DART SERVICE INSTRUCTION

TO AMEND INSTALLATION INSTRUCTIONS: IIN-D206-667 REV. C
 REF. CANADIAN STC: SH01-5
 REF. FAA STC: SR01304NY

DESIGN	PH	DART AEROSPACE LTD HAWKESBURY, ONTARIO, CANADA
DRAWN	B	
CHECKED	ASS	DRAWING NO. REV. M
MFG. APPR.	N/A	DSI 9346 SHEET 1 OF 2
APPROVED	140	TITLE SCALE
DE APPR.	140	DEVIATION ON D206-667 & D407-667 NTS
DATE	11.07.28	COPYRIGHT © 2006 BY DART AEROSPACE LTD THIS DOCUMENT IS PRIVATE AND CONFIDENTIAL AND IS SUPPLIED ON THE EXPRESS CONDITION THAT IT IS NOT TO BE USED FOR ANY PURPOSE OR COPIED OR COMMUNICATED TO ANY OTHER PERSON WITHOUT WRITTEN PERMISSION FROM DART AEROSPACE LTD.

FIGURE 1 - INSTALLATION OF DART CROSSTUBES ON BHT/AAI SKIDTUBE

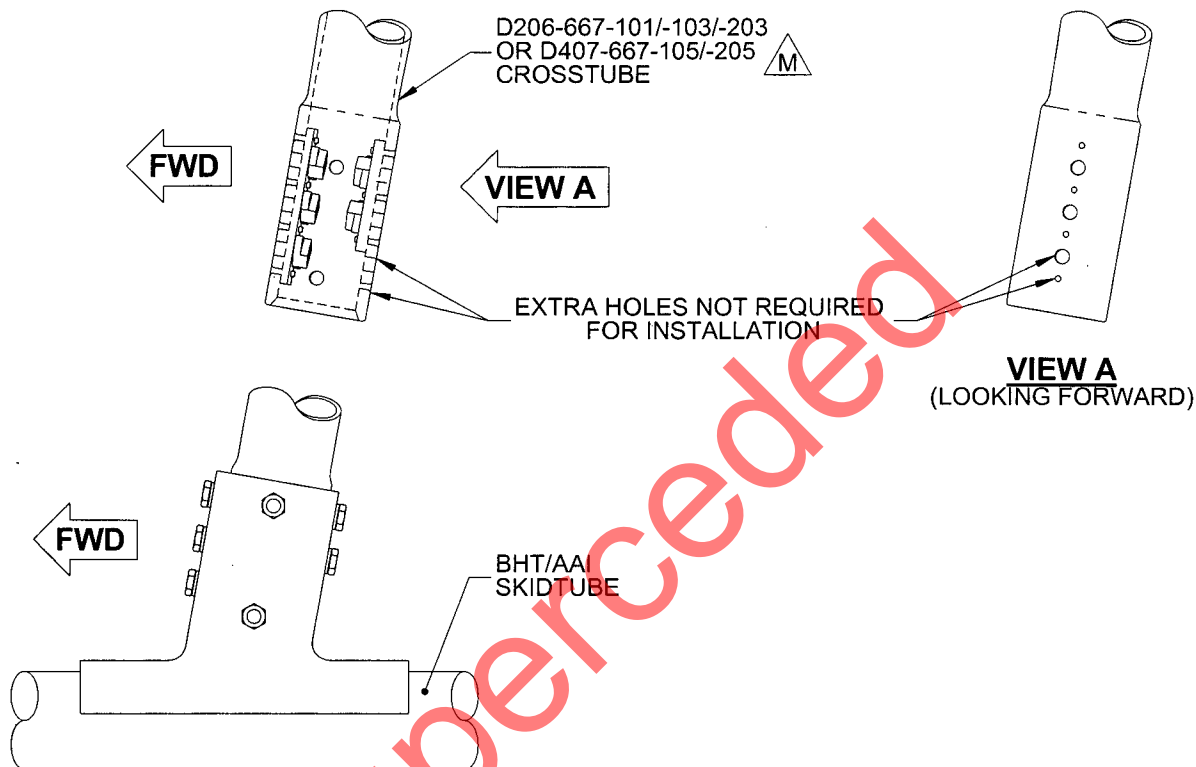
THE FOLLOWING D206-667-101/-103/-203 AND D407-667-105/-205 CROSSTUBES HAVE EXTRA HOLES DRILLED ON THE AFT SIDE OF THE CUFFS. THIS HOLE IS NOT REQUIRED FOR INSTALLATION OF DART CROSSTUBES ONTO BHT/AAI SKIDTUBES AS SHOWN IN FIGURE 1.

CUSTOMERS RECEIVING CROSSTUBES AT CHG 002 PRIOR TO 06.08.08 SHOULD CONTACT DART FOR DISPOSITION IF INSTALLING THE DART CROSSTUBES ONTO BHT/AAI SKIDTUBES PER IIN-D206-667 REV. C.

CUSTOMERS RECEIVING CROSSTUBES AT CHG 002 PRIOR TO 06.08.08 TO BE INSTALLED WITH DART SKIDTUBES MAY FIND THAT THE SUPPORTS HAVE BEEN INSTALLED BACKWARDS. THE SUPPORTS SHOULD BE REMOVED AND RE-INSTALLED PER ICA-D206-667.
